Levin-Richmond Terminal Corporation

February 18, 1997

Re: United Heckathorn Superfund Site Work Plan - Completion of Dredging in the Lauritzen Channel

ATTACHMENT “A”

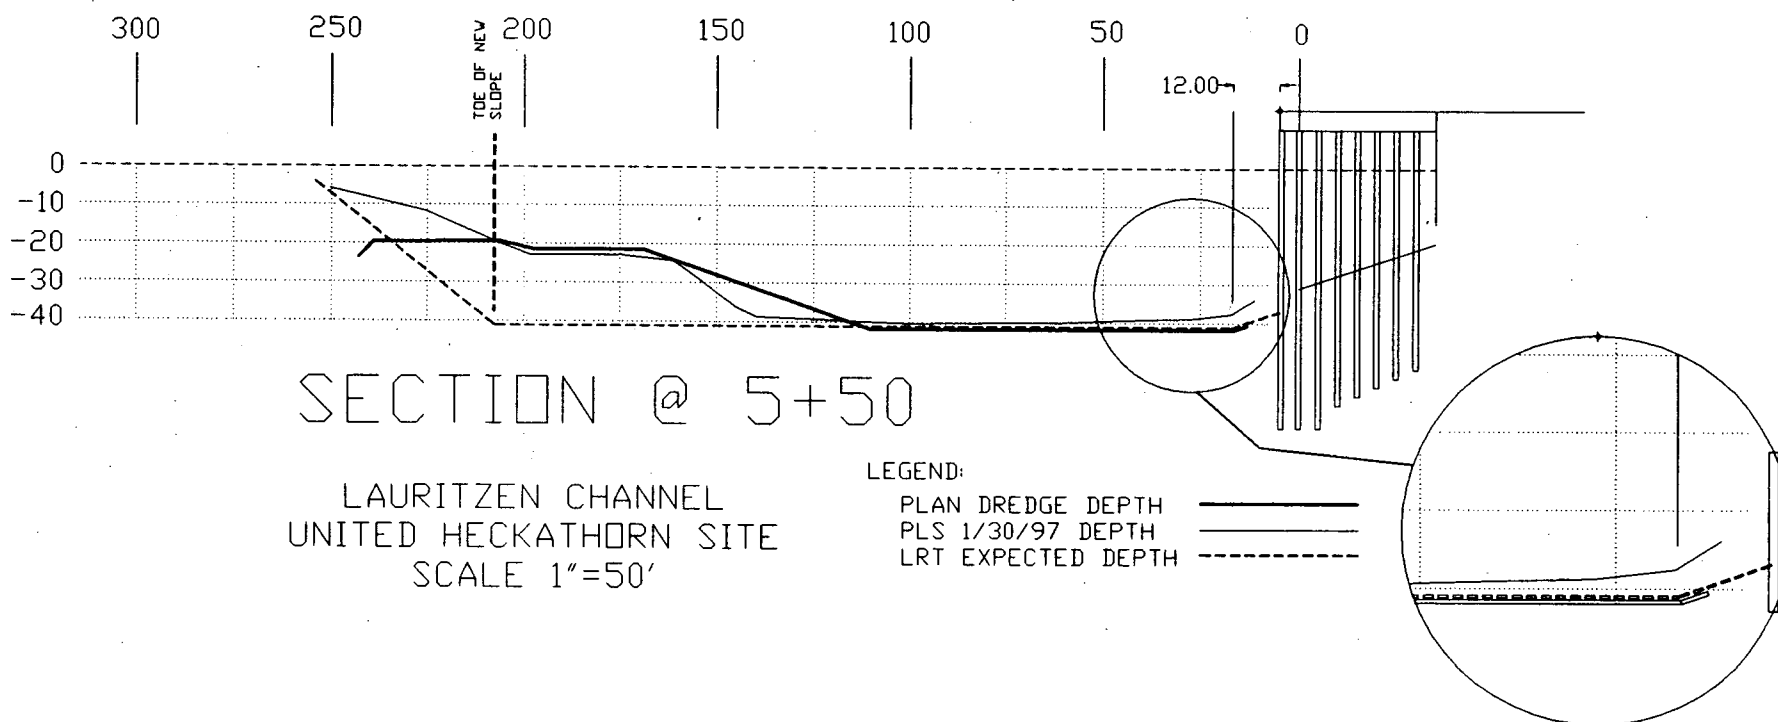
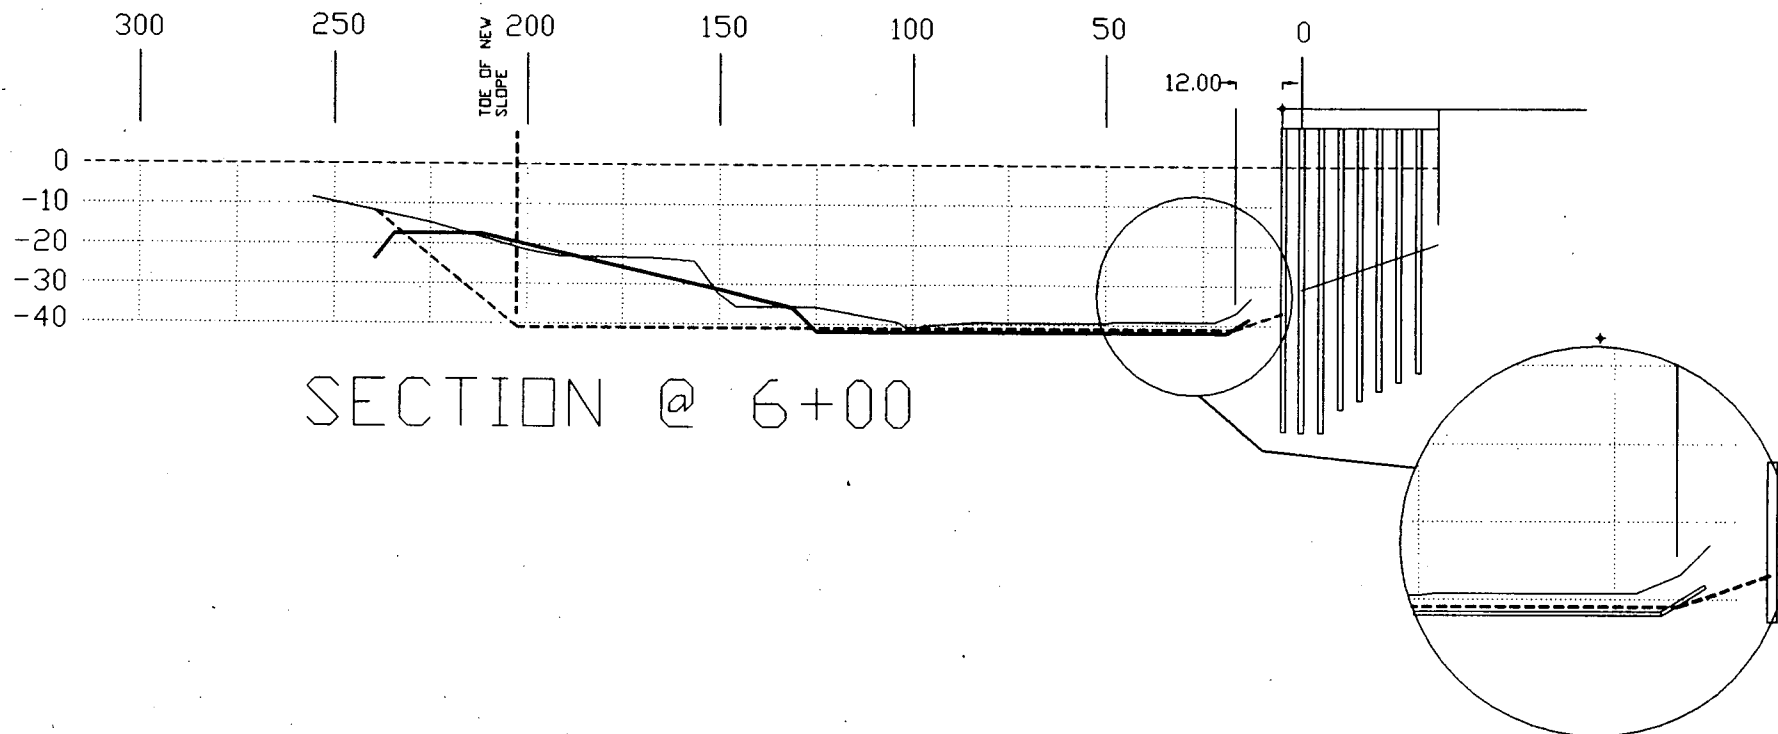
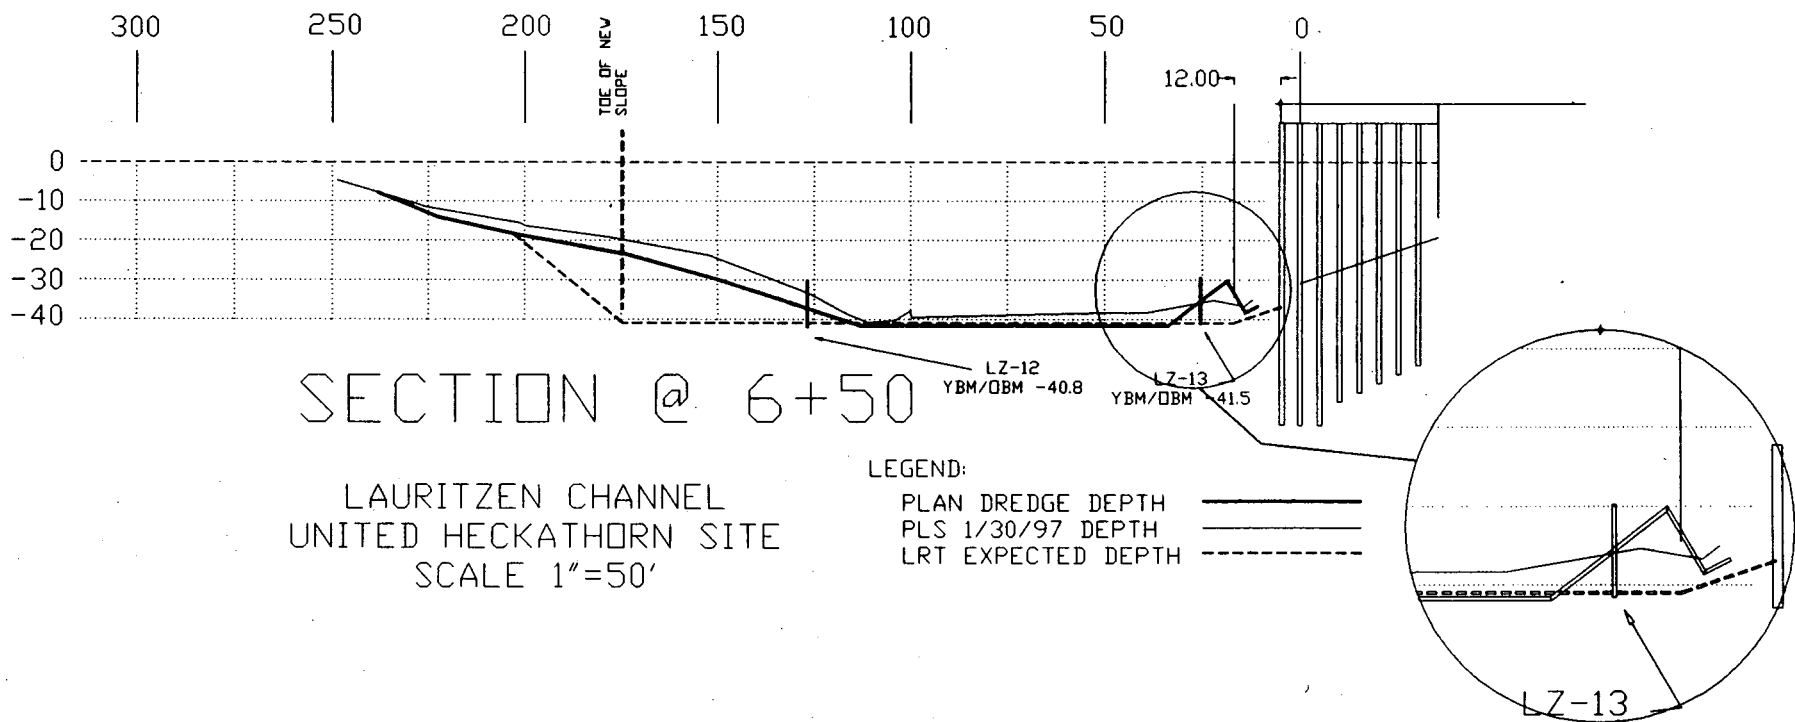
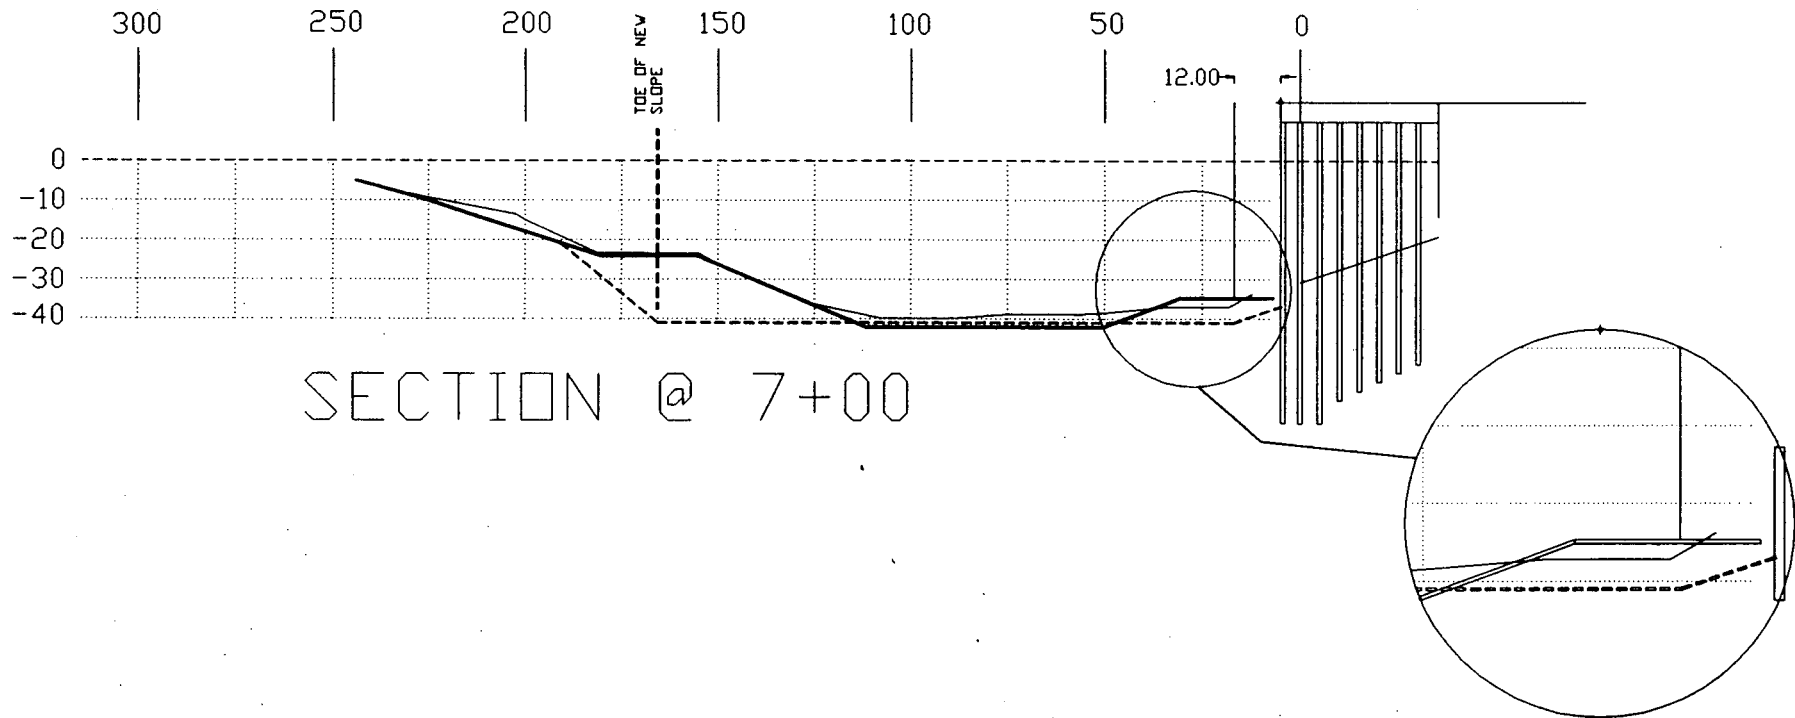
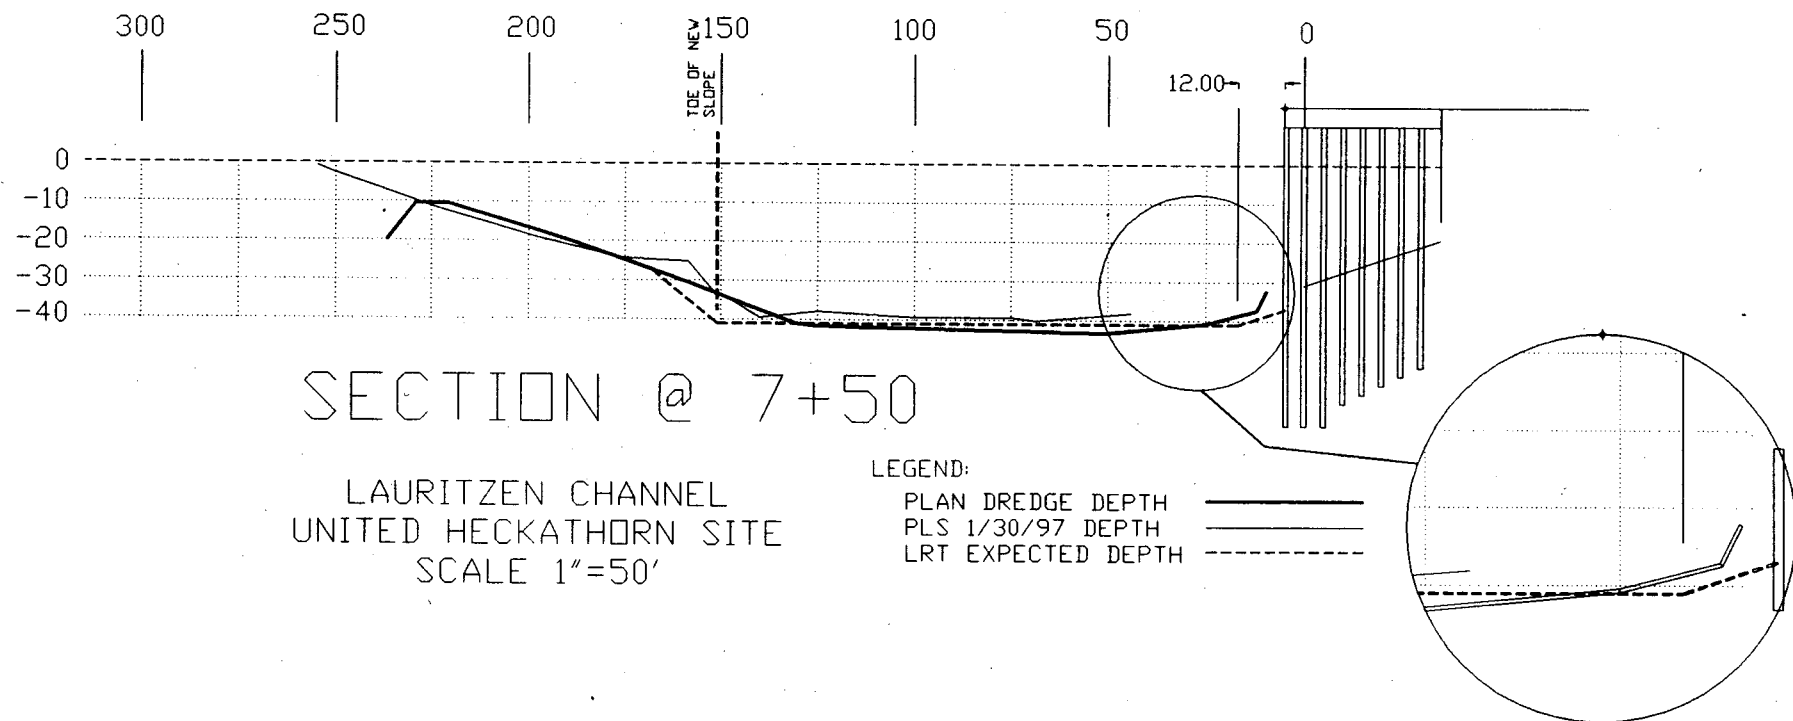
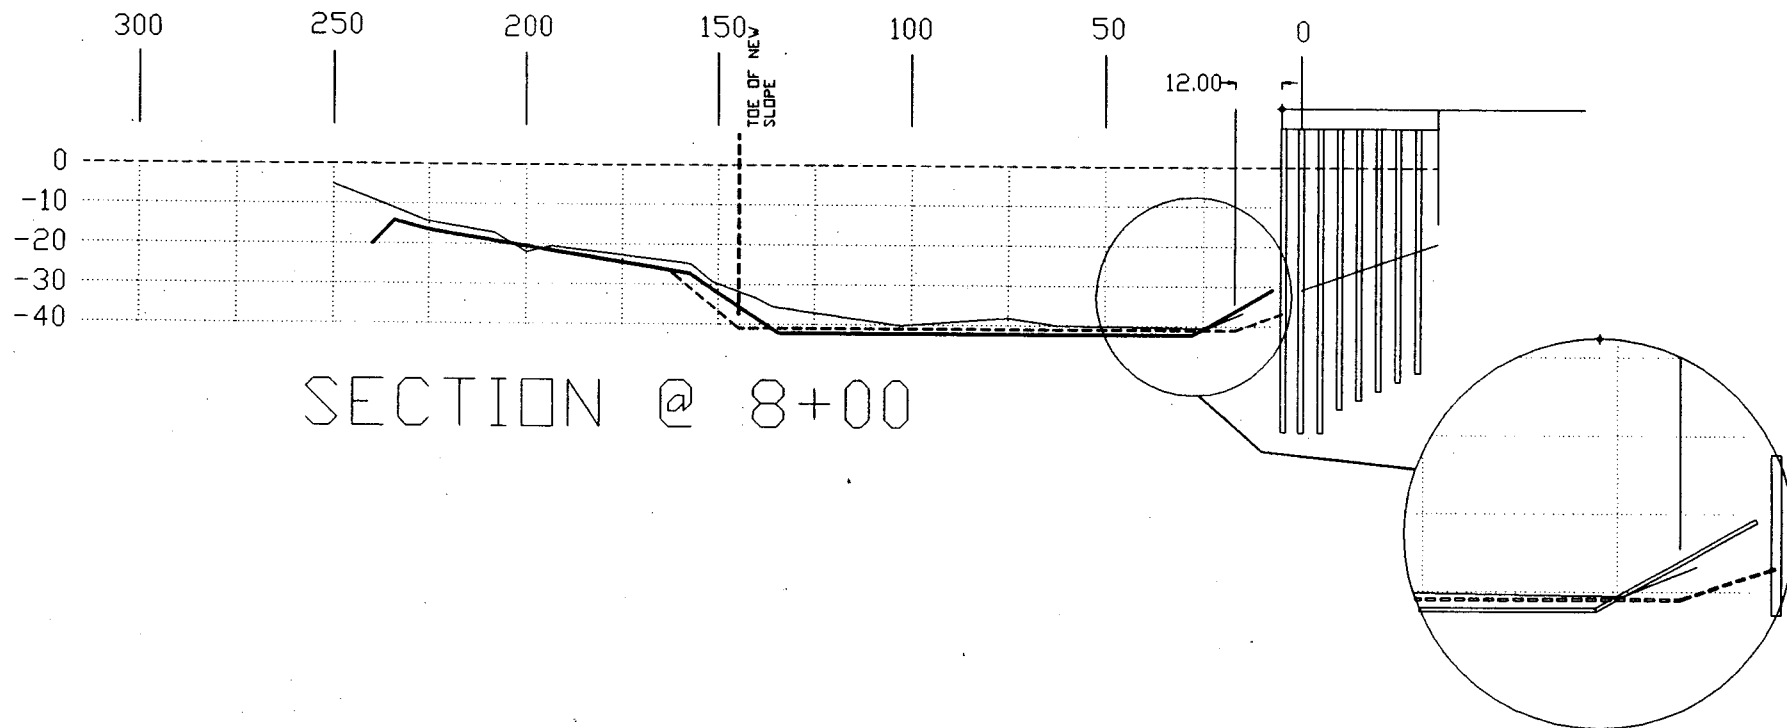
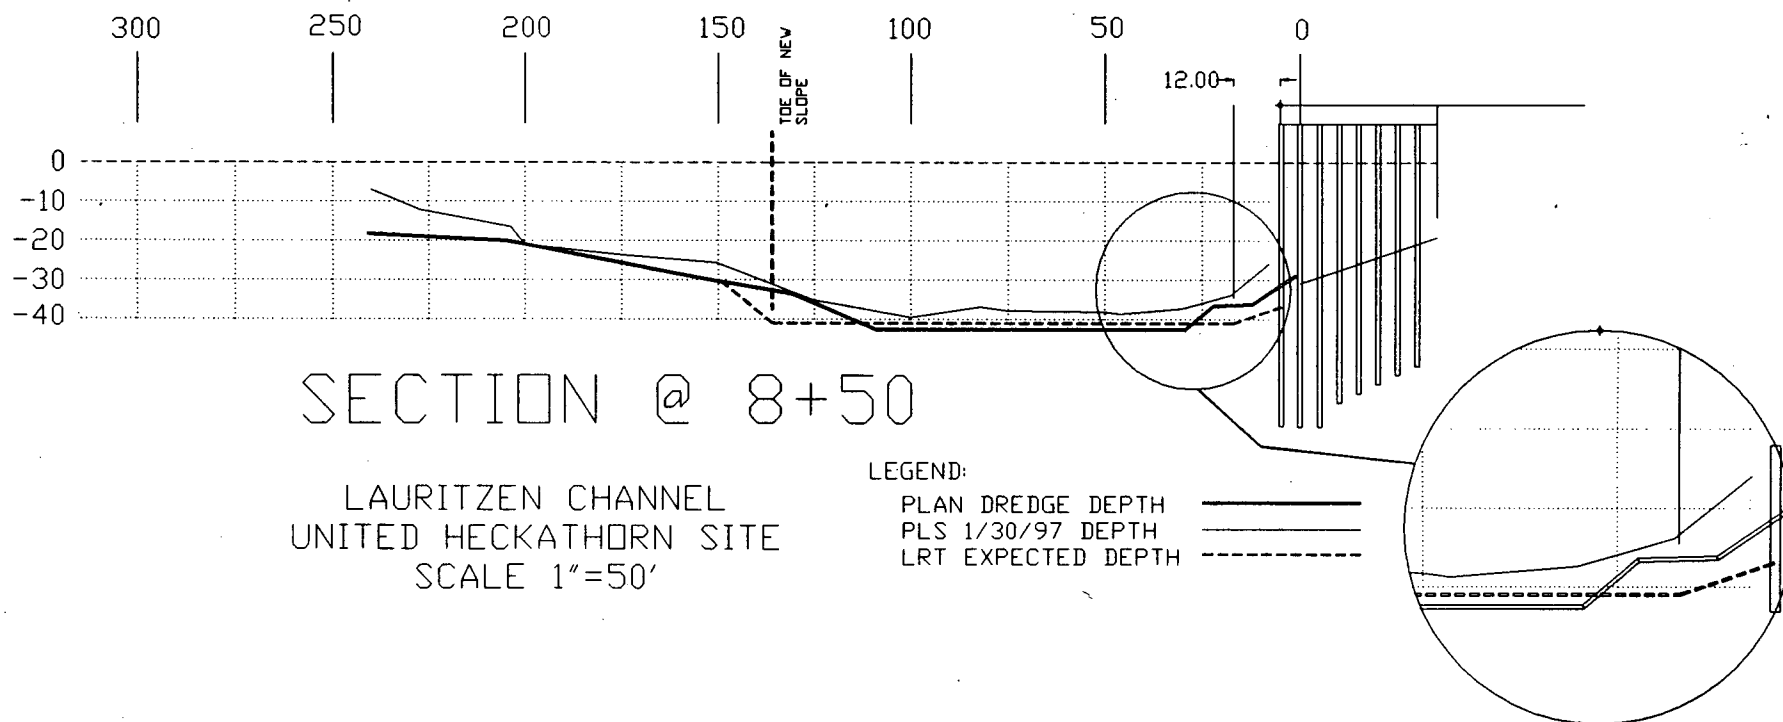
To compare the Work Plan Appendix A and the Channel Cross Sections (Exhibit #3) with the depths indicated on the PLS survey dated January 31, 1997, we have used CAD drawings to superimpose both documents on the attached cross sectional drawings (LRT Attachment #A). We have plotted each 50 ft. interval to get a better understanding of the depth of the remaining material to be removed according to the Work Plan, and have included them for your review and response. Also included are copies of the core samples taken by Battelle indicating the depth of the YBM/OBM interface. We don't have access to the samples used to map the interface, however, the depth appears to be

From these observations it is clear that the Work Plan depths have not been achieved. There are discrepancies from 2 ft. to over 10 ft. of YBM containing contaminated materials that have not been dredged. Note on section 9+00 that the Battelle core sample LZ-10 indicates the YBM/OBM interface at -40.7 ft. and that the plan depth is shown at -41 ft., but the dredged depth, as shown, is approximately 15 ft. shallower. (See the included grid map for Battelle core sample locations and depths, LRT Attachment C.) The depths indicated in the Work Plan should be the guideline to assure that all of the dredgable contaminated material has been removed. As the site owners we want to insure that all of the contamination required to be removed by the Montrose Consent Decree and Work Plan have been removed.
